**Advisory Action
Before the Filing of an Appeal Brief**

10/790,923

FRYE, NANCY C.

FIG. 12

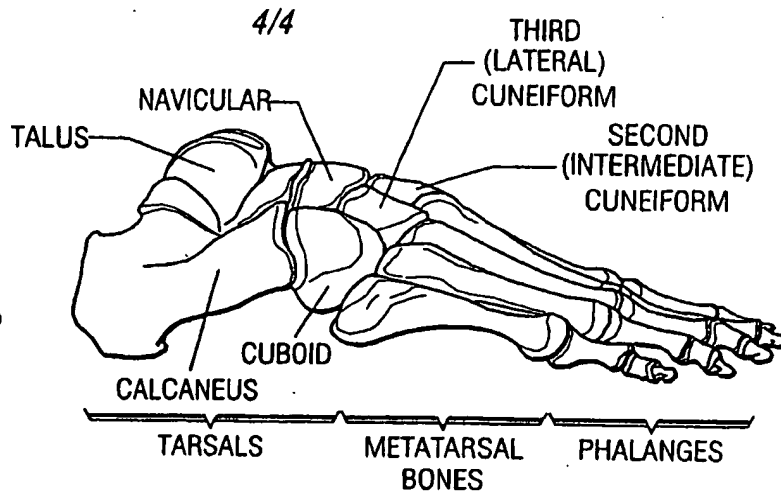
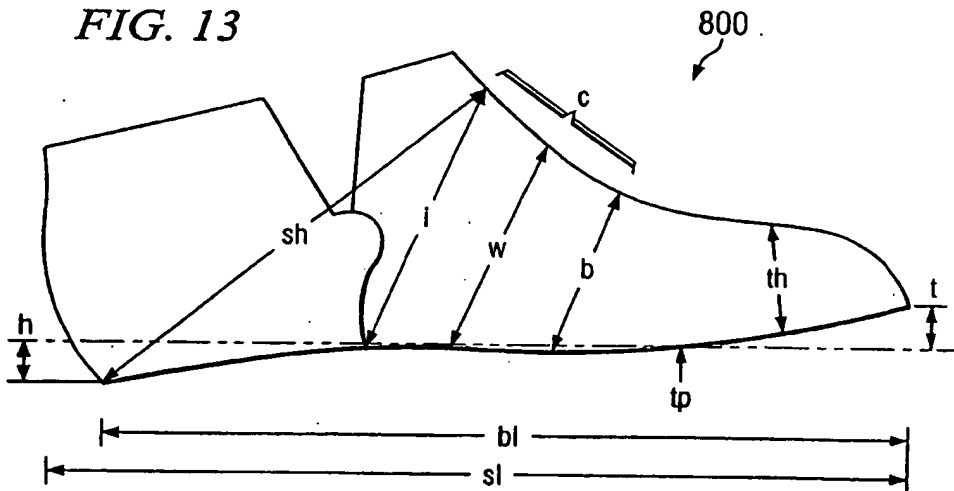
Continuation of 3. NOTE: The proposed amendment to the drawings raise new issues and new matter.

*Do Not enter
mfr 2/16/06*
